N4850A-01

S E R V I C E N O T E

N4850A Digital Analysis Probe

Installation of spacer to eliminate grinding fan noise

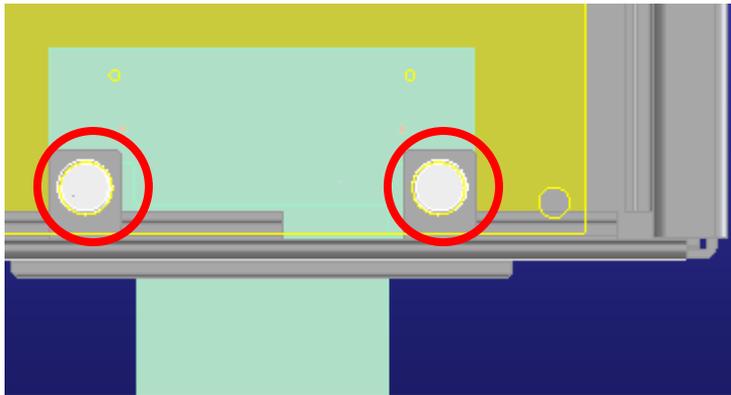
Some units exhibit a mechanical fan noise after shipping/transportation. The root cause of this issue is that the clearance for the fan assembly did not allow for worst case parts tolerances. On the defective units it is likely that the mechanical tolerances of parts allowed for the fan cable to slide out of its routing cavity onto the top of the fan housing during shipment. The cable sliding out of position put extra pressure on the fan housing, causing the deflection of the fan housing that interferes with the rotation of the fan blades.

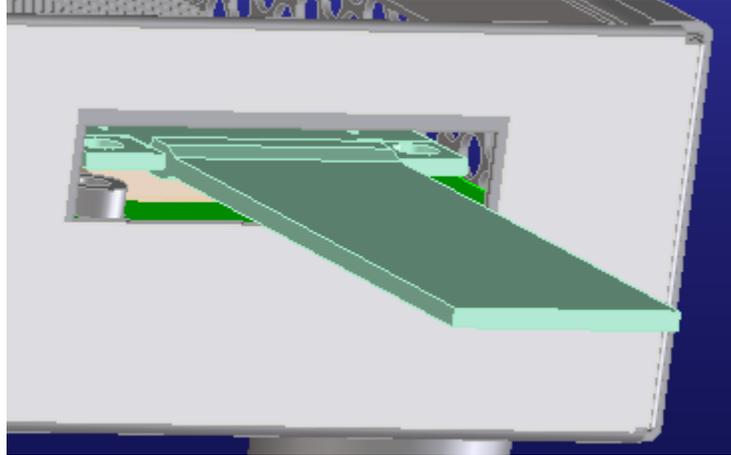
1. Remove the (4) cover screws (0515-0372, M3x8mm). *Set aside for re-use.*
2. Remove the cover
3. Remove the (4) hex stand-off hardware (0380-1631 M3x16mm) securing the PCA into the chassis. *This hex stand-off hardware will be replaced with new hardware upon re-build.*
4. Remove the remaining (5) screws (0515-0372, M3x8mm) securing the PCA into the chassis. *Set aside for re-use.*
5. N4850A only: Remove the (2) screws (0515-0375, M3x16mm) securing the cable into the PCA. *Set aside for re-use.*

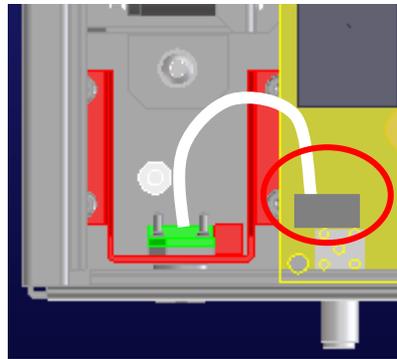
6. N4850A only: Remove front panel cable brackets (N4850-21601), first the top one and then the bottom one. *Set aside for re-use.*

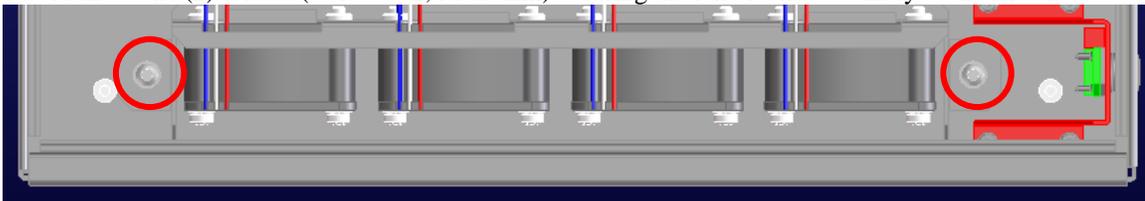
7. N4850A only: Unplug the cable and remove through the front panel of the chassis. *Set aside for re-use.*
8. Unplug power connector cable from the PCA
